**Rezoning from "Residential (Group C) 2" and "Open Space" zones to
"Residential (Group C) 4" zone for a Proposed Residential Development
at Lot Nos. 519 RP (part) and 520 RP in D.D. 110 and adjoining Government land,
Shek Kong, Yuen Long, N.T.**

(S12A Amendment of Plan Application No. Y/YL-KTN/6)

- Further Information No. 2 -

Comments Forwarded from Fanling, Sheung Shui and Yuen Long East District Planning Office (FSS&YLE DPO)

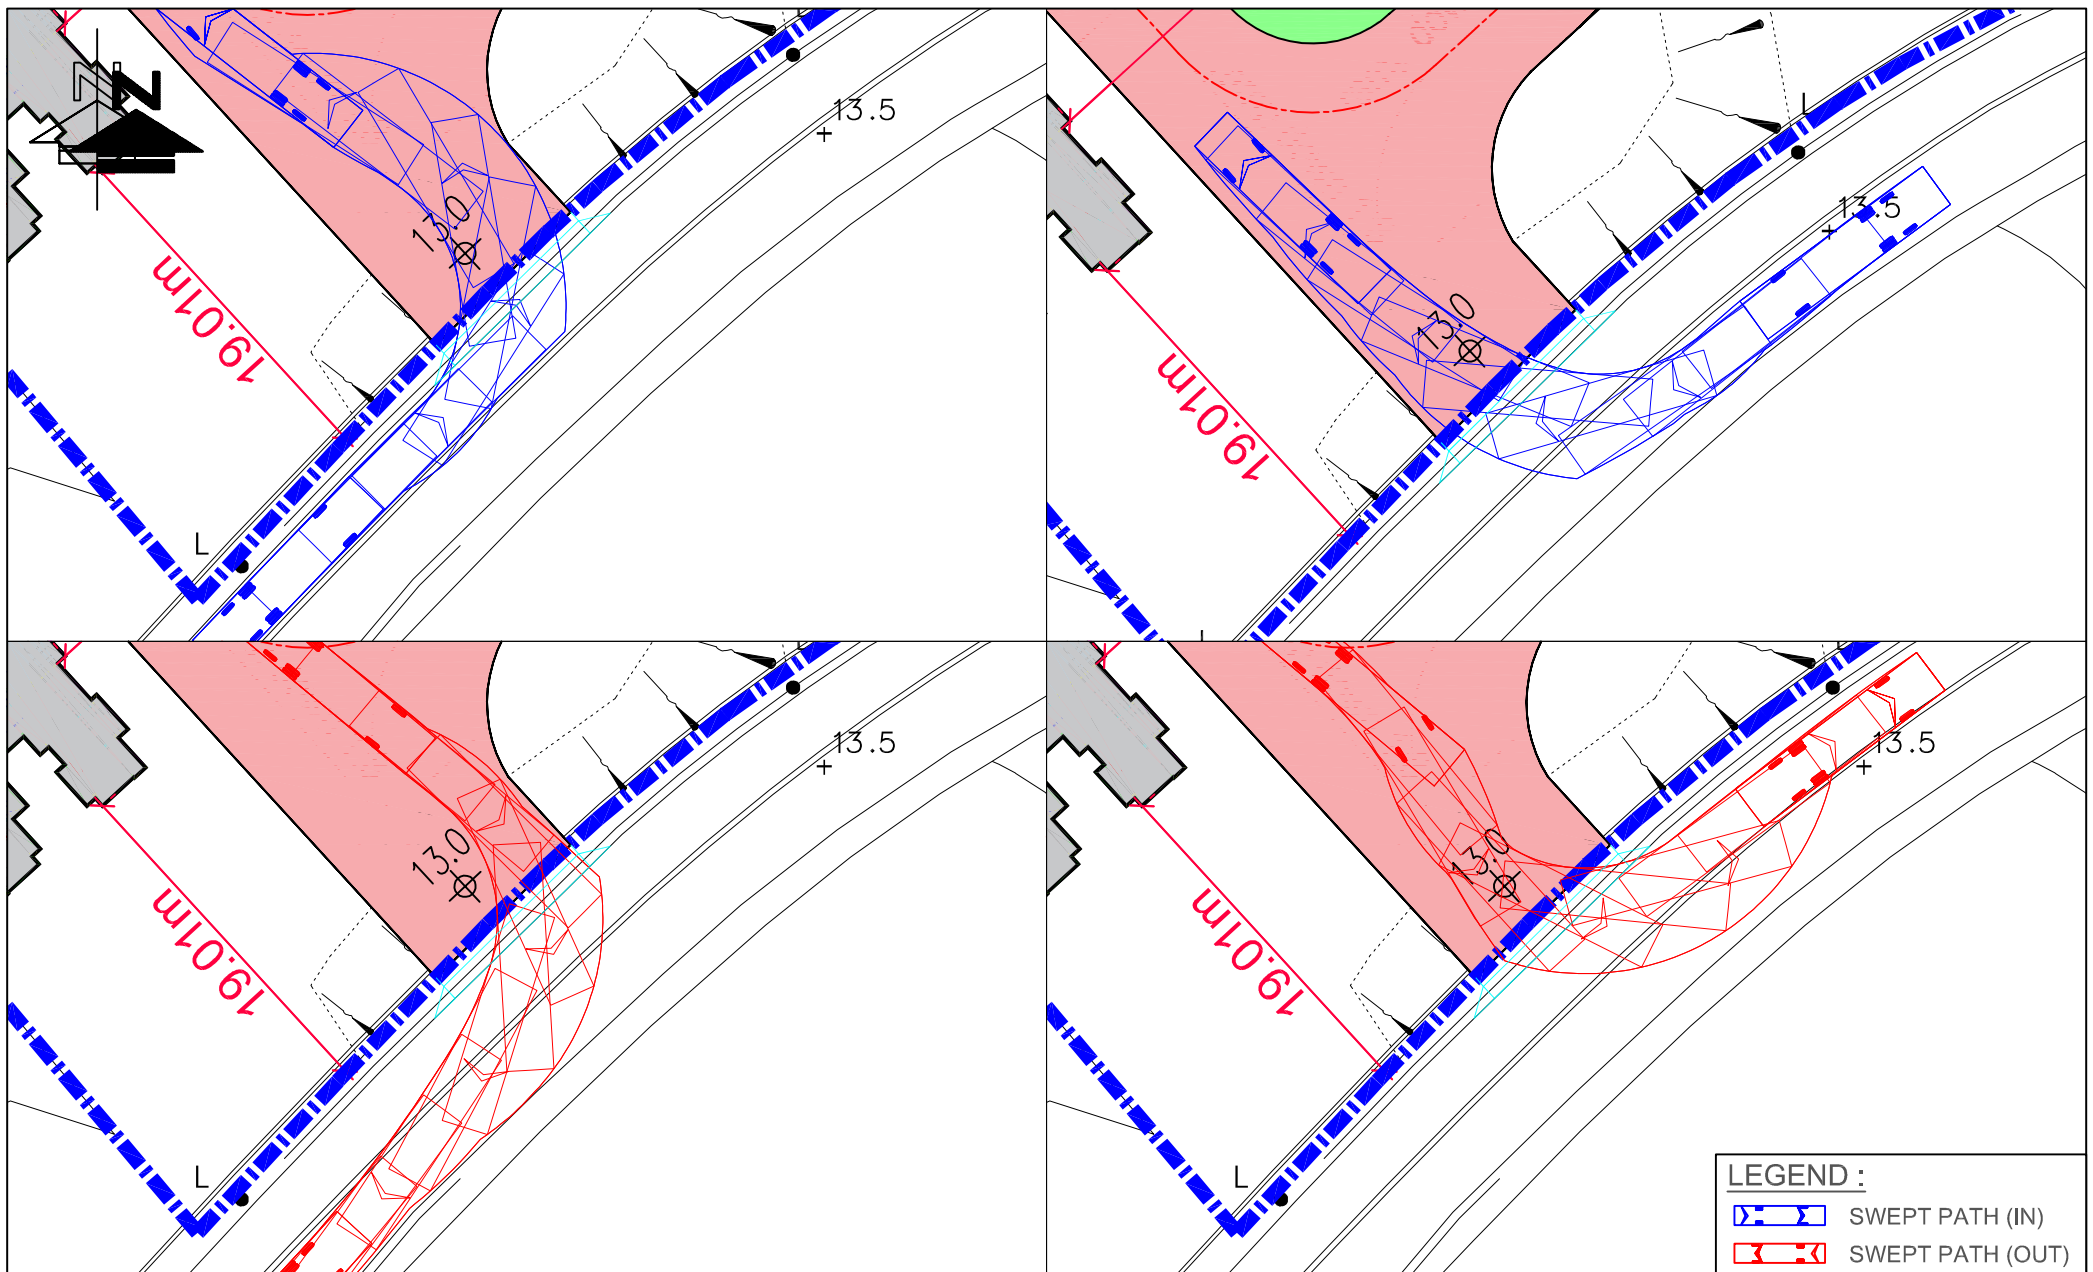
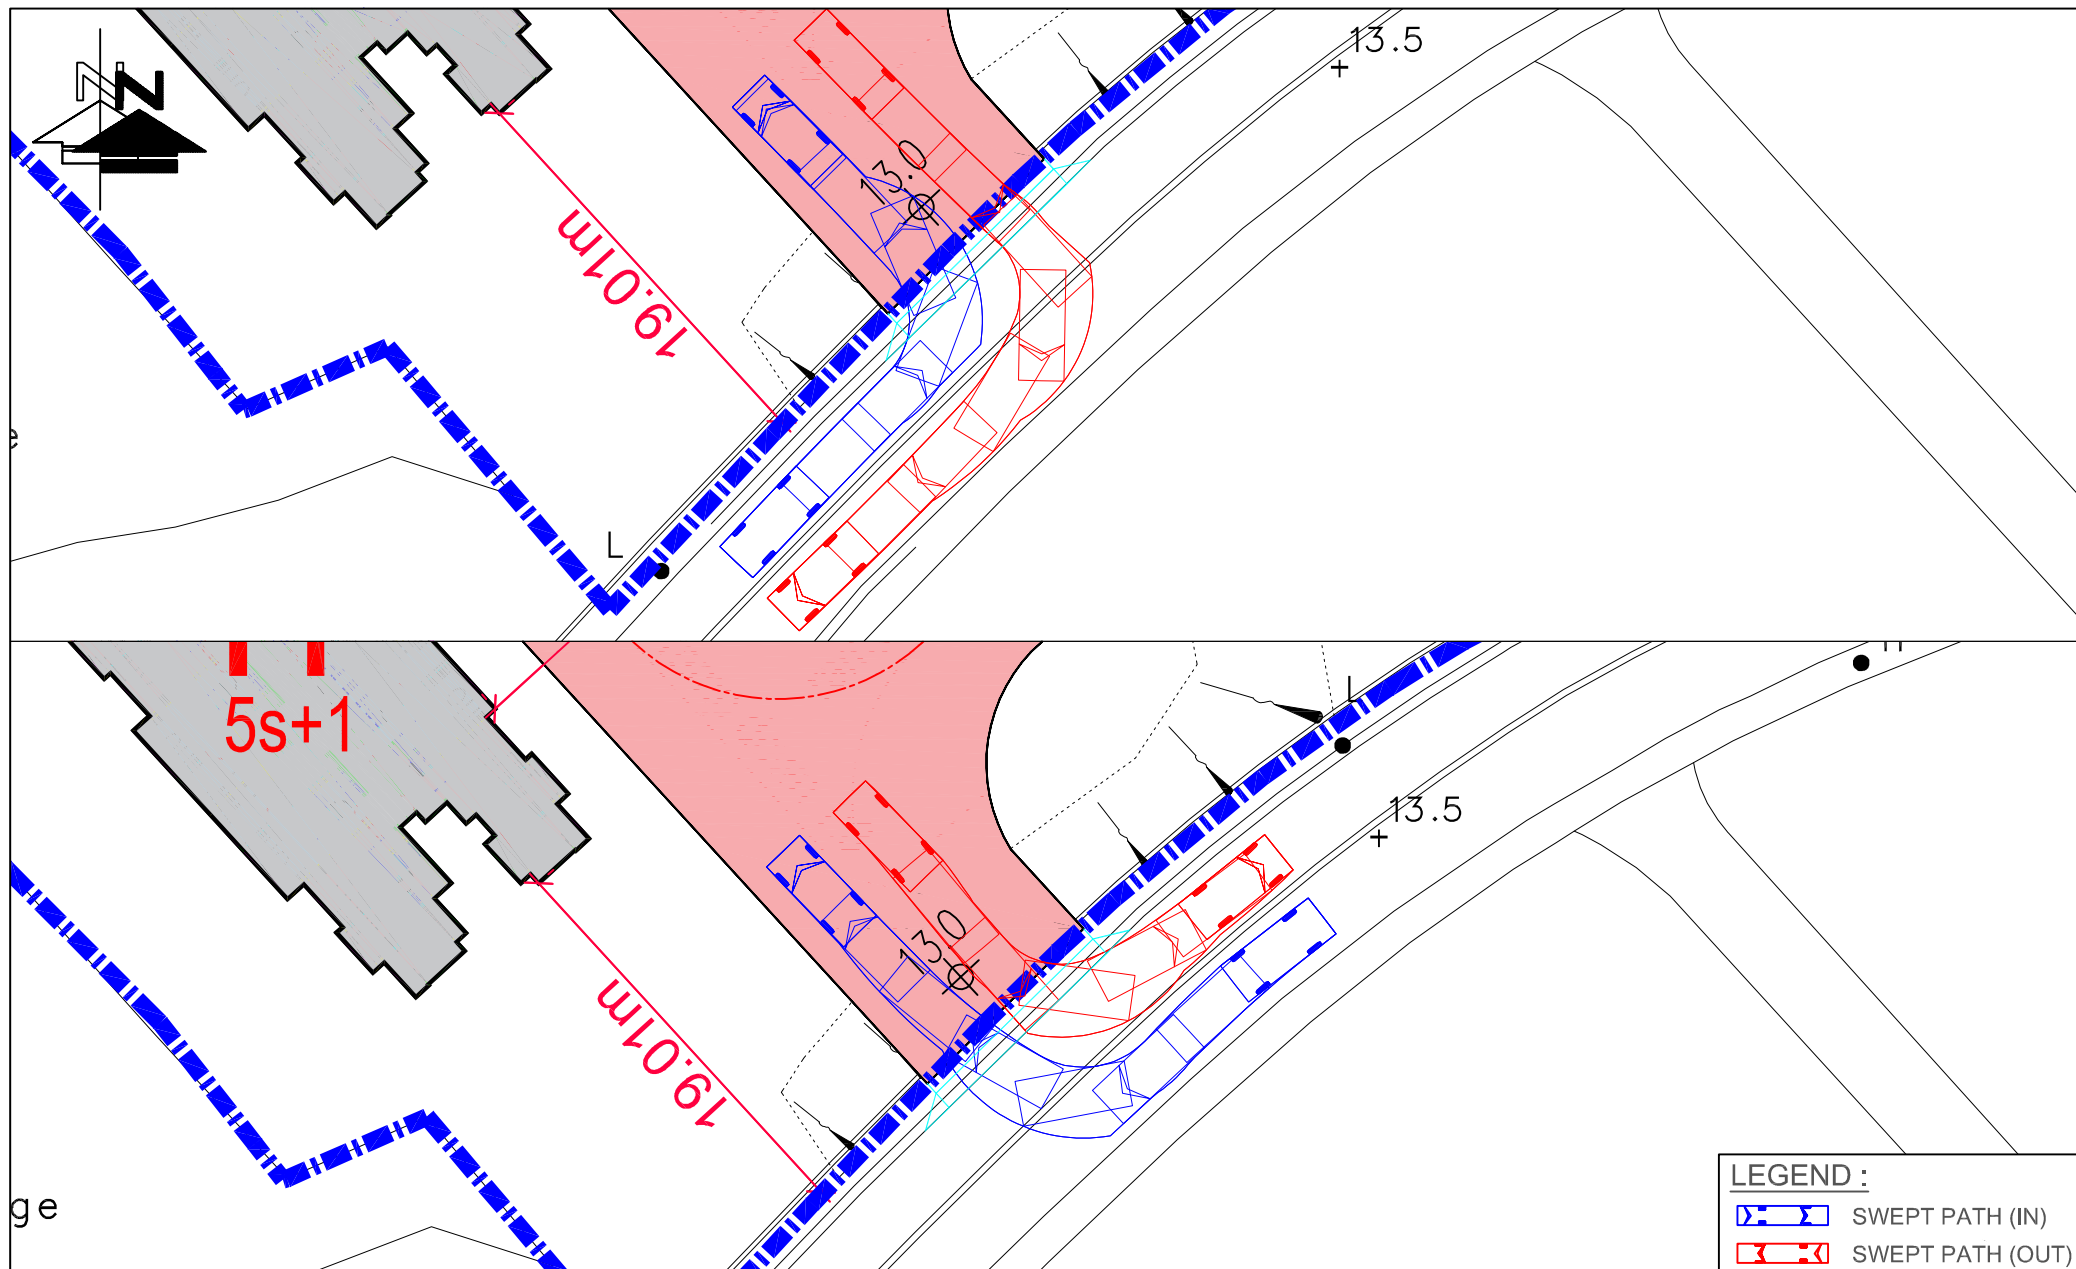
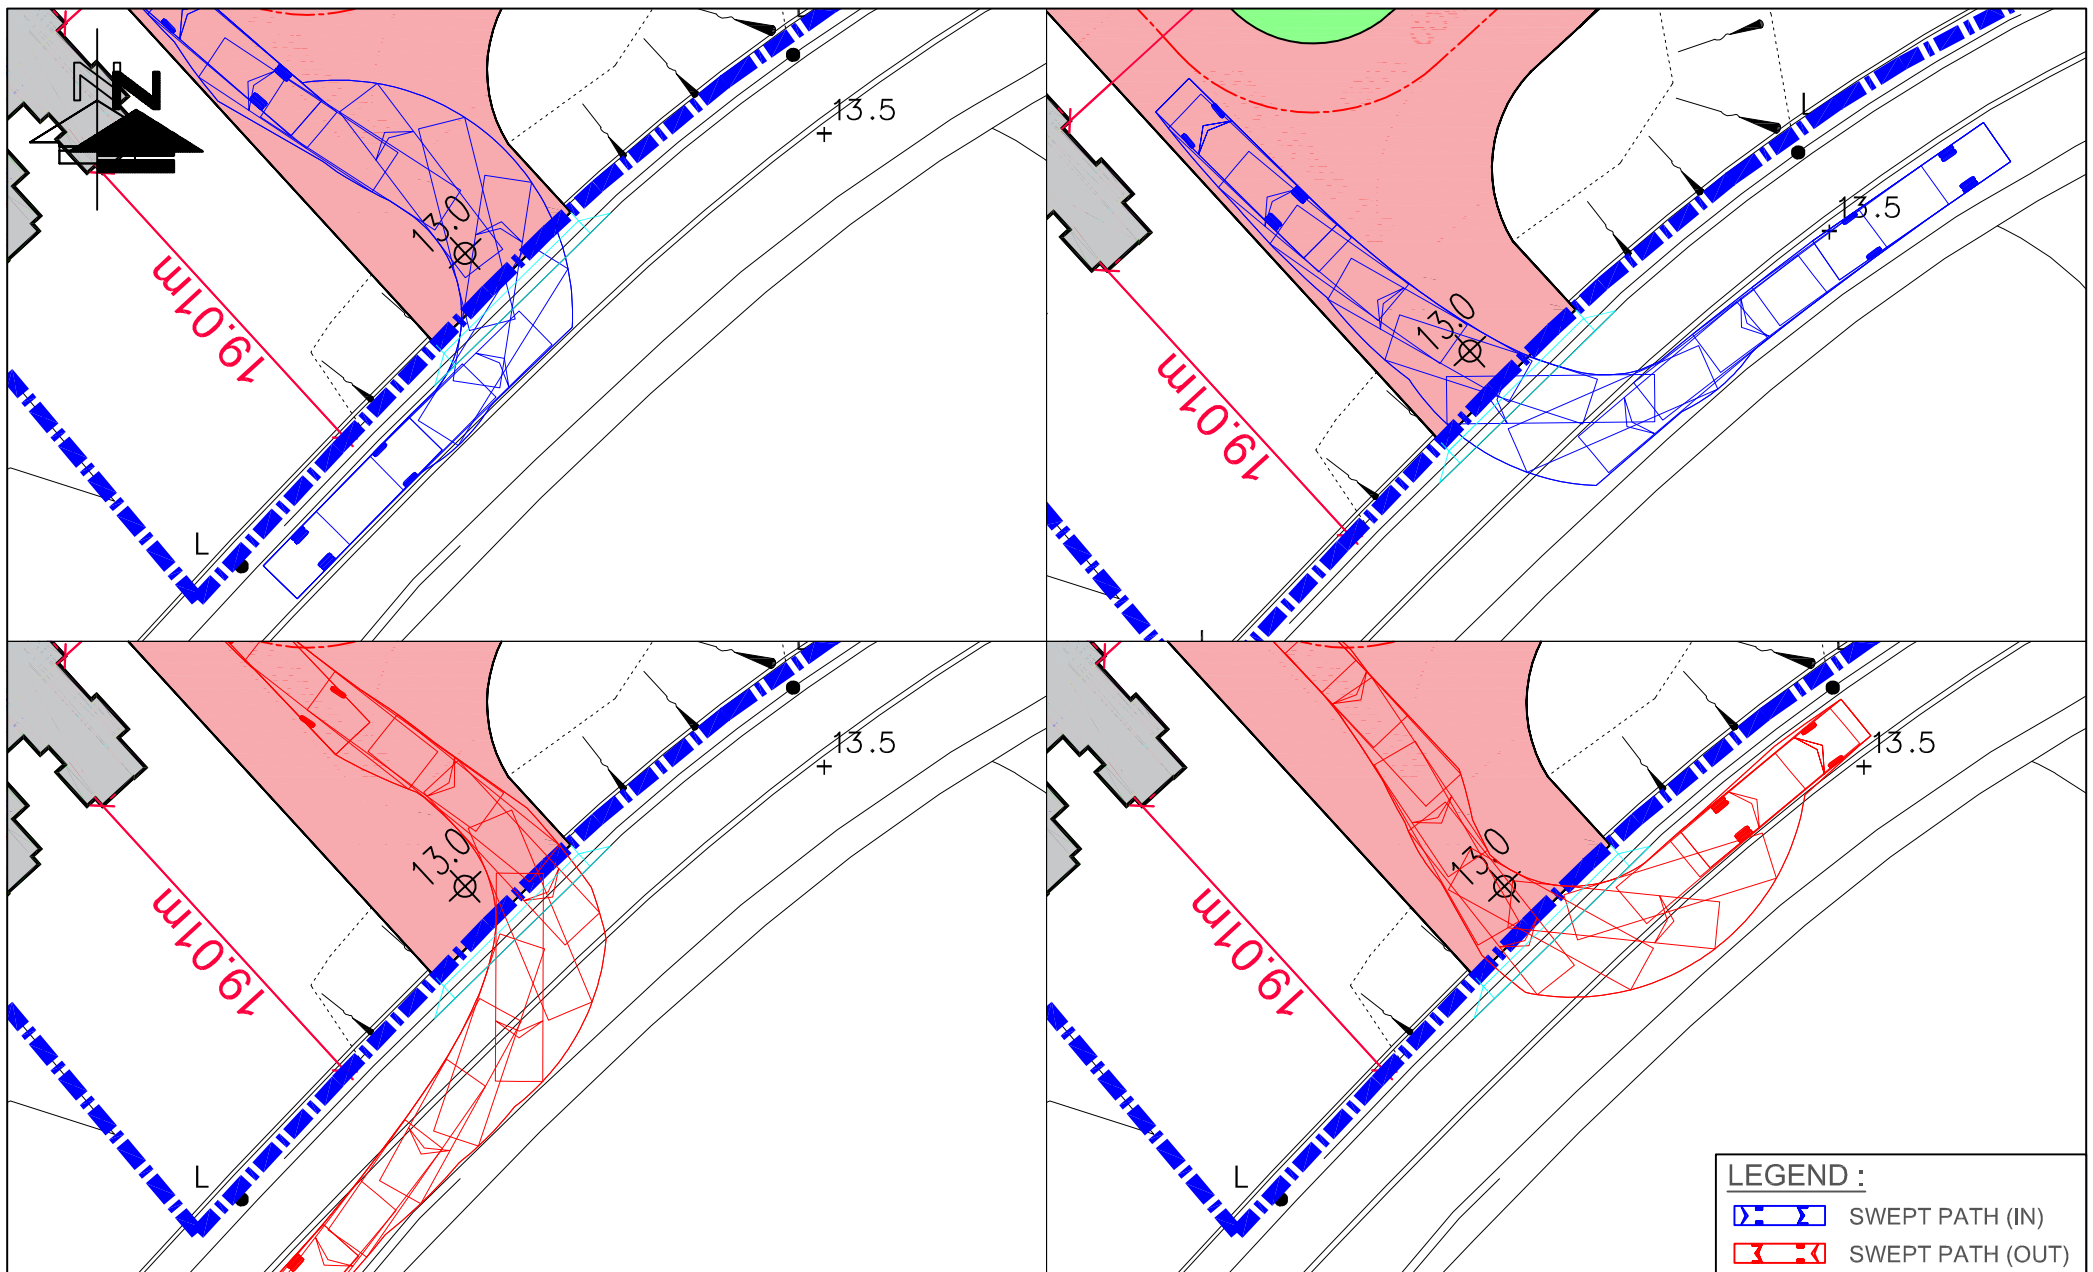
Figure 2.1 - The swept path analyses showed that vehicles may experience difficulties in entering and exiting the development. The applicant should demonstrate how to provide sufficient space and ensure unobstructed manoeuvre of vehicles. The distance between the development run-in/out and the nearest junction shall be indicated.	Since the trip generation of the Proposed Development is low and there are only 6 HGV L/UL bays, the chance of large vehicles ingress/egress is not high. Moreover, in the previous TIA, to reduce the cross traffic conflict, it was already proposed to ban vehicles longer than 7m from turning left from the proposed development. This proposal was included in the TIA under the previous planning application (S12A Application No. Y/YL-KTN/4) without receiving adverse comments from TD.
Figure 5.1 - Please elaborate whether the proposed work will be in conflict with the public works project. The party being responsible for the works shall be indicated.	The proposed work is with reference to the planned PWP works but only involves local widening on Junction C. It will not be in conflict with PWP

- Figure 2.1 - The swept path analyses showed that vehicles may experience difficulties in entering and exiting the development. The applicant should demonstrate how to provide sufficient space and ensure unobstructed manoeuvre of vehicles. The distance between the development run-in/out and the nearest junction shall be indicated.

2.5.1 As shown in **Figure 2.1 (SP3)**, since existing Kam Tin Road is narrow, long vehicles would have difficulty turning left from the proposed development and will encroach into the opposite lane. To minimize the impact to the public road, it is proposed all egress vehicles longer than **7m** are only allowed to turn right to westbound. Traffic signs will be erected as shown in **Figures 2.3 and 2.3 (SP)** to restrict the turning movement.

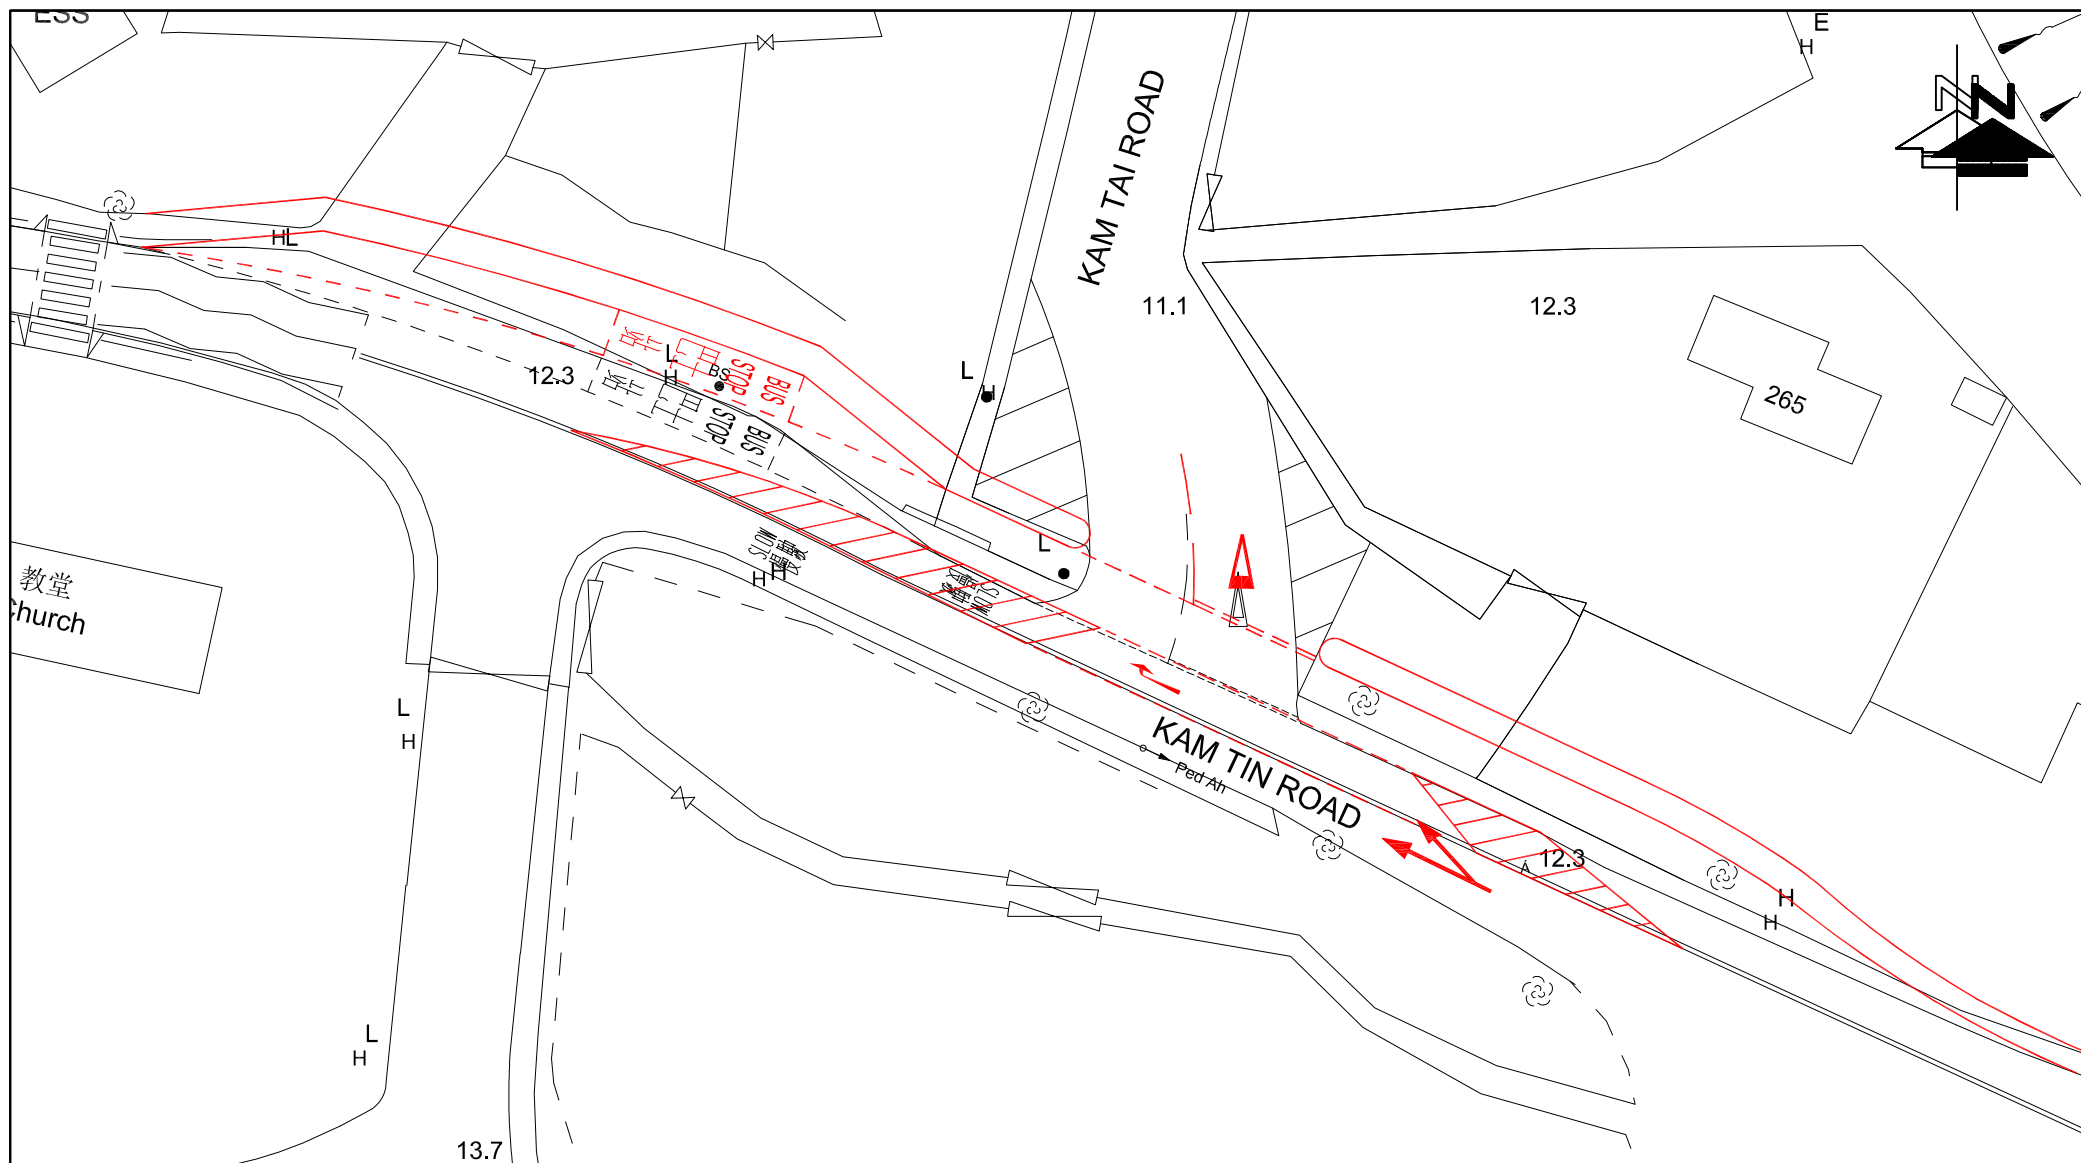
- Figure 5.1 - Please elaborate whether the proposed work will be in conflict with the public works project. The party being responsible for the works shall be indicated.

Comments	Responses
	works. Further elaboration on the proposed works is added under Table 5.11 of the TIA. Junction C could operate with ample capacity after the PWP works of Kam Tin Road. However, as the programme of PWP works are still under review, the PWP works may be delayed. In case delay occurs, the Applicant will carry out the proposed improvement works in advance to PWP works before the implementation of the Proposed Development.
Comments from Drainage Services Department (received on 12 January 2026) Contact person: Ms. Jessica KWAN; Tel. No.: 3965 8924	
<u>Drainage Impact Assessment (DIA)</u>	
<u>(A) Specific Comments</u>	
1 The applicant should clarify if any works are proposed to be carried out at Site 2.	Please be clarified that there are no works proposed to be carried out at Site 2.
2 Appendix B2: The applicant should clarify discharge path at the downstream of the proposed 300 mm (W) and 600 mm (W) surface channels.	The flow directions of the proposed 300mm(W) and 600mm (W) surface channels are indicated in Appendix B2. Besides, Section 4.1.2 is revised to clarify the discharge path of the proposed channels. Please refer to the revised Drainage Impact Assessment report in Annex C of this FI submission.

5.3.3 For Junction C, an improvement scheme is proposed as shown in **Figure 5.1**. The Applicant considers carrying out the improvement works as per the improvement scheme, in case of programme mis-match between the development and the public works project.
